**BEDFORD REGIONAL WATER AUTHORITY
SMITH MOUNTAIN LAKE WTP &
RAW WATER PUMPING STATION / INTAKE**

**MECHANICAL
RAW WATER INTAKE PUMP STATION VAULT
PLAN AND SECTION**

M-20-101

BEDFORD REGIONAL WATER AUTHORITY
SMITH MOUNTAIN LAKE WTP &
RAW WATER PUMPING STATION / INTAKE
MECHANICAL
ELECTRICAL BUILDING
OPERATING FLOOR PLAN

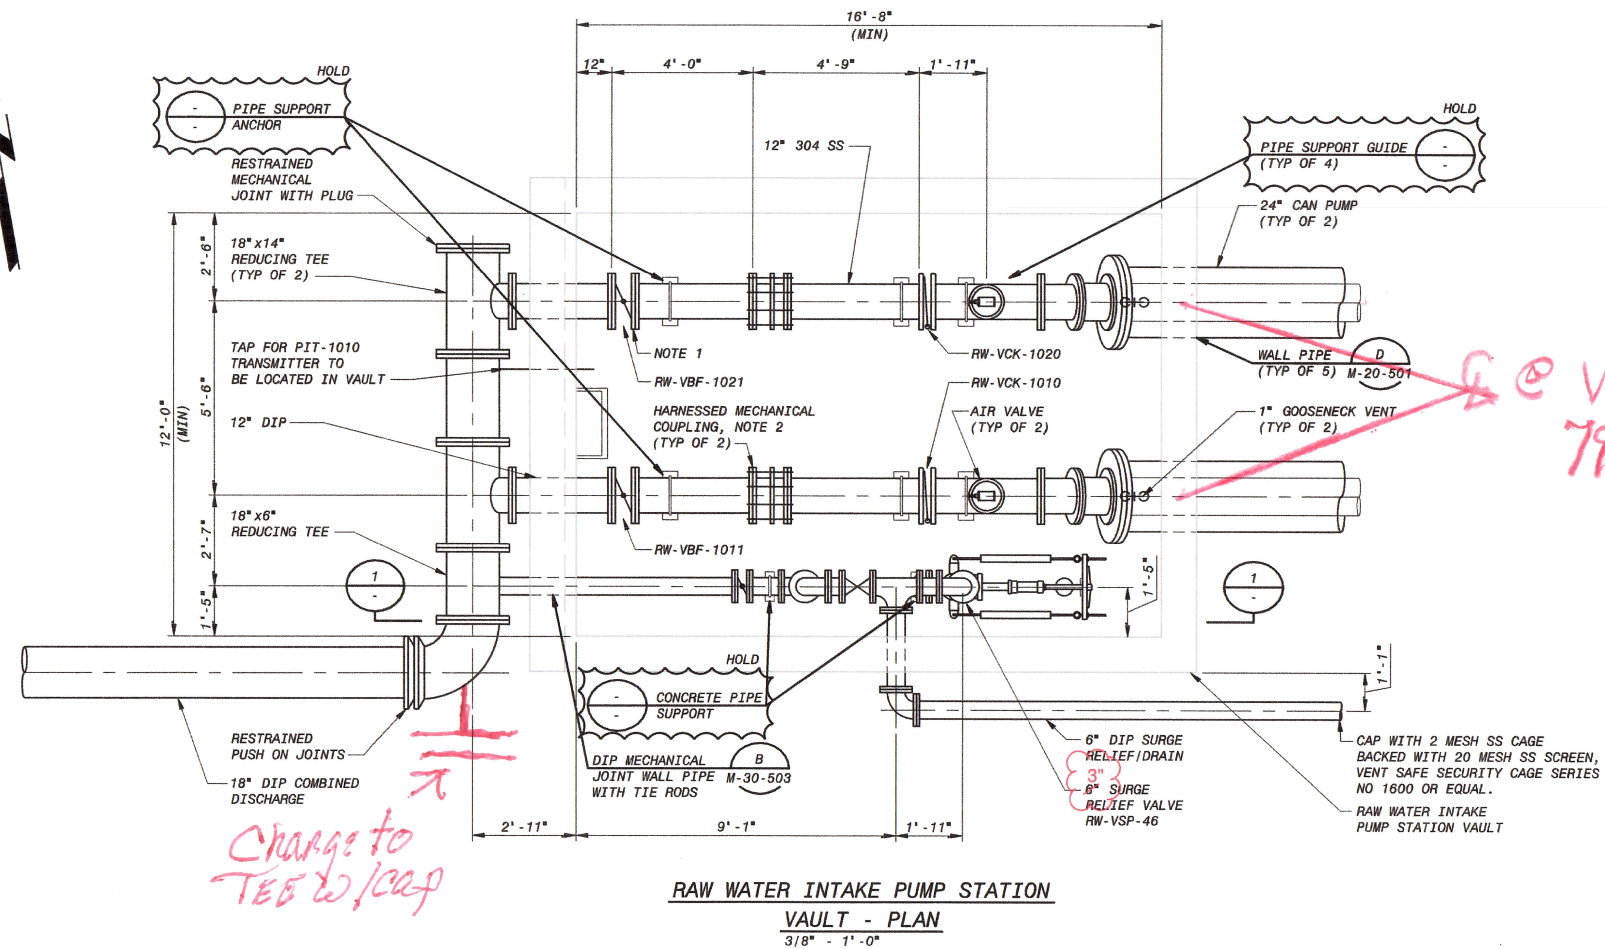
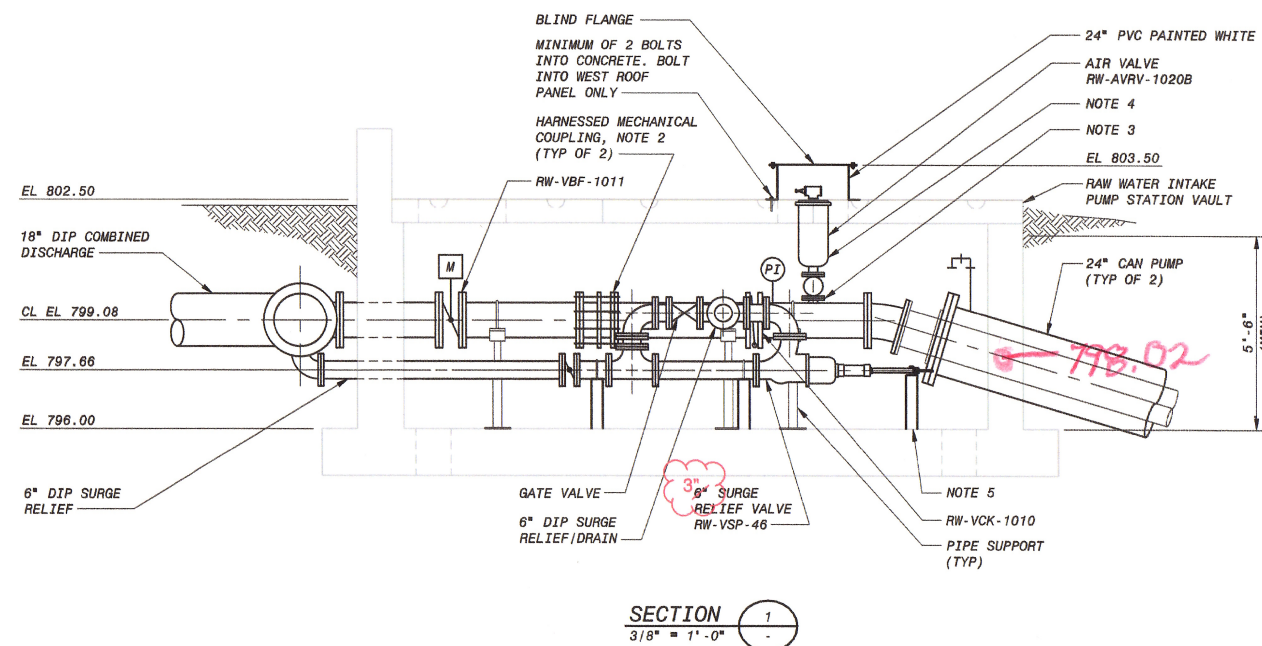
Charge to
TEE W/cap

@ Wall
798.02

Revised

RFI 21

ECN-007

OPERATING FLOOR PLAN
1/2" = 1'-0"

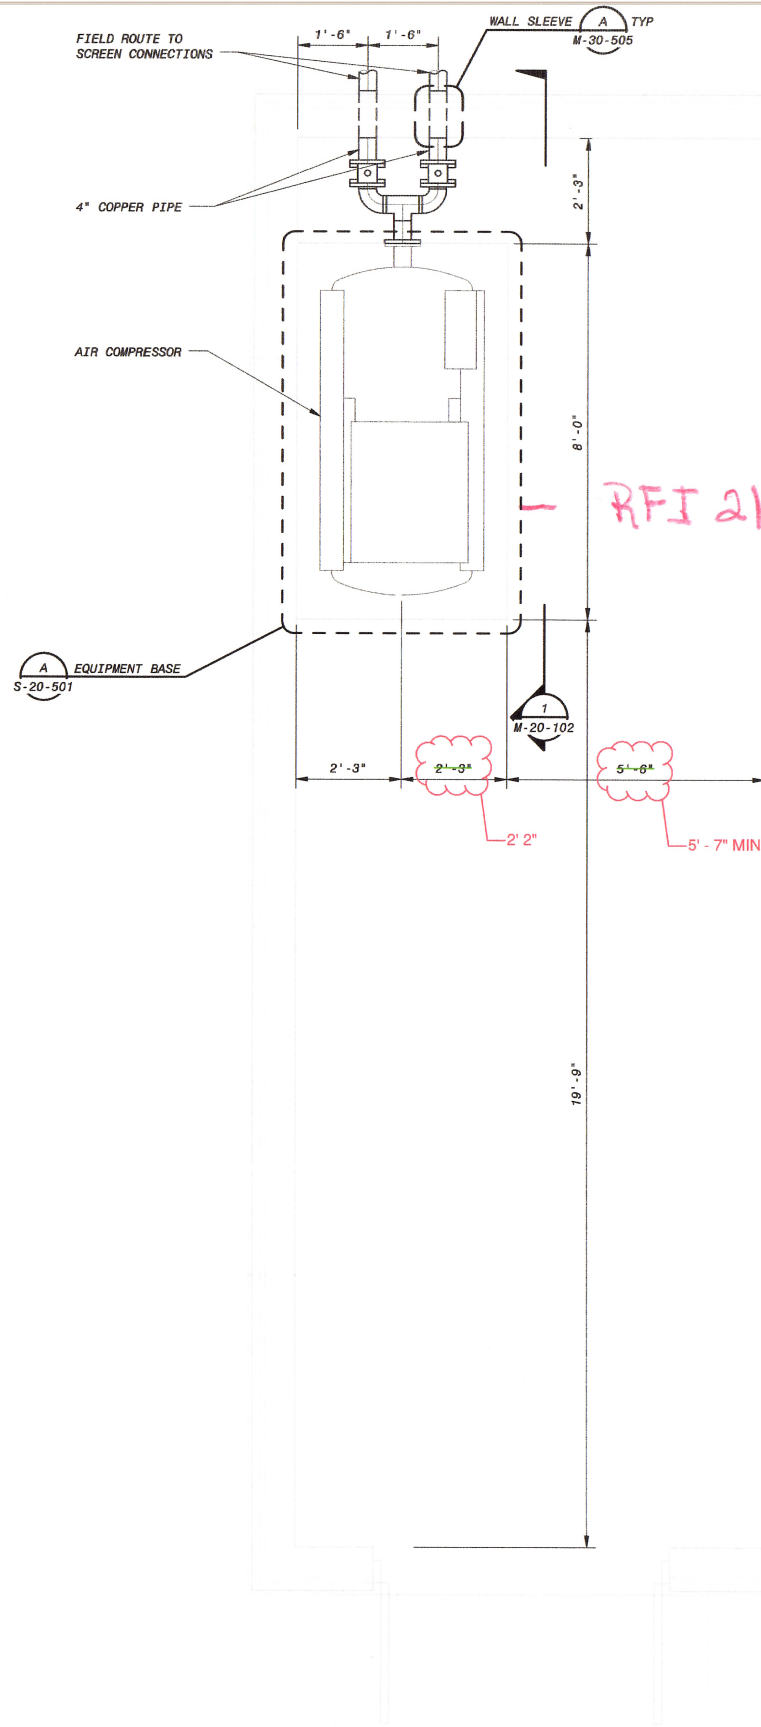
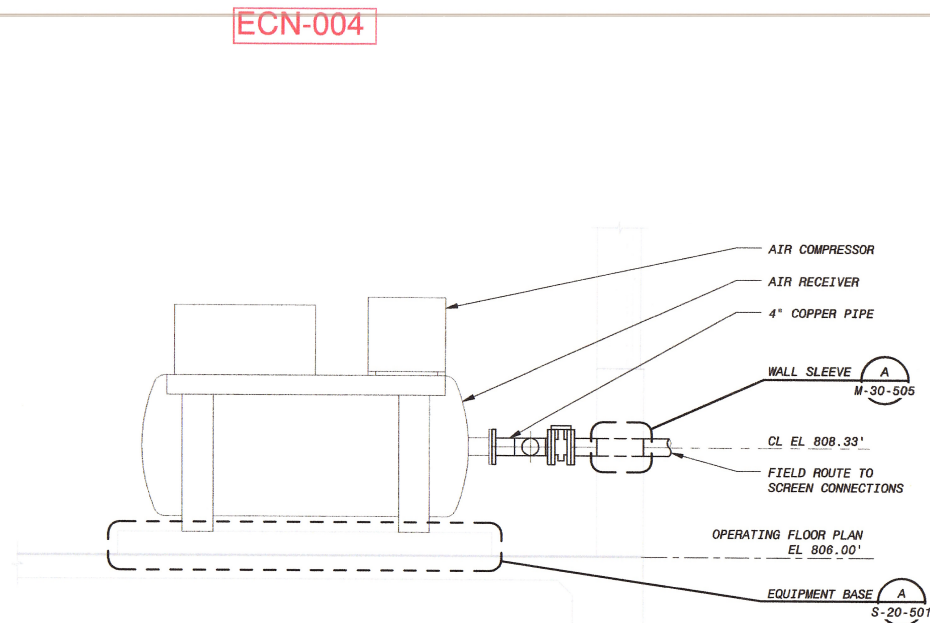
ECN 4

ECN-004
